# Historical Architectural Review Board COA Final Review Sheet

**HDC-2023-00036**

**Address: 449 N. 10<sup>th</sup> Street**

**Proposal: Reconstruct masonry fire escape**

Liberty Street fire escape before demolition, 2021.  
(Google StreetView)

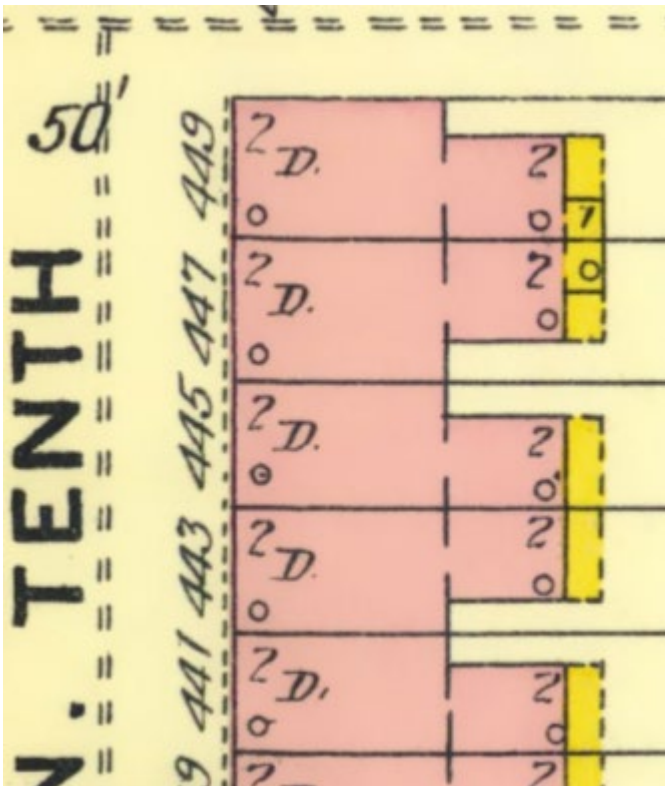
Building Standards and Safety determined the fire escape to be unsafe and required that the structure be partially demolished and reconstructed. While staff approved a certificate of appropriateness to reconstruct the rear ell in-kind, the application proposes to change the upper portion of the fire escape to wood frame construction with brick veneer. The brick would match the dimensions of the existing masonry and would be painted to match the building's facades. Staff is requesting that the HARB review the application, owing to the material change.

Staff finds that the fire escape, as a later addition, is not a character-defining feature of the property and contends that maintaining the appearance of the original fire escape, despite the material change, would largely comply with the guidelines in Section 3.3 Masonry, provided that the brick veneer matches the dimensions, texture, bond pattern, and joint dimensions of the existing masonry.

Approval, provided the brick veneer matches the dimensions, texture, bond pattern, and joint dimensions of the existing masonry, with the staff to review details, pursuant to Chapter 3, Section 3.3 Masonry.

Liberty Street façade and fire escape before demolition, 2021.  
(Google StreetView)

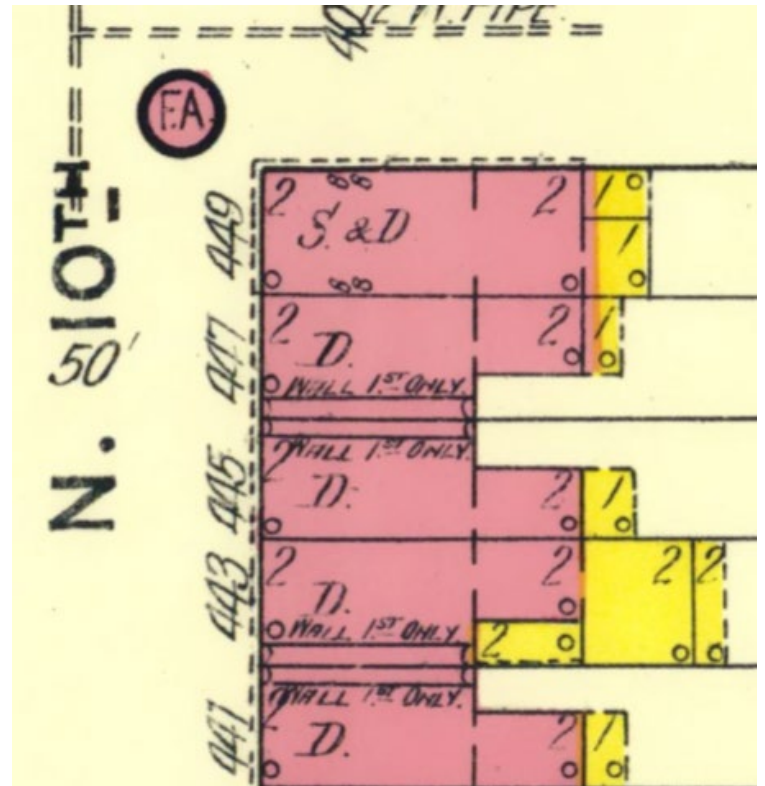
The HARB discussed the appropriateness of rebuilding the masonry fire escape using thin brick and found that if the brick matches the historic appearance, then it would be appropriate. The HARB noted that there is some irregular coursing and other issues in the photos of the proposed thin brick and noted that the existing would need to be matched in dimensions, coursing, and texture. The HARB also concluded that the façade should be painted to match the rest of the building.

The applicant noted that an additional load-bearing beam would be installed at the fire escape and would be visible from the exterior. The HARB found the additional beam to be acceptable.

Mr. Hart moved to approve the application with conditions presented on 9/5/2023 to rebuild the masonry fire escape at 449 N. 10<sup>th</sup> Street, pursuant to Chapter 3, Section 3.3 Masonry, provided the brick veneer matches the dimensions, texture, bond pattern, and joint dimensions of the existing masonry. Mr. Encelewski seconded the motion, which carried with unanimous support.
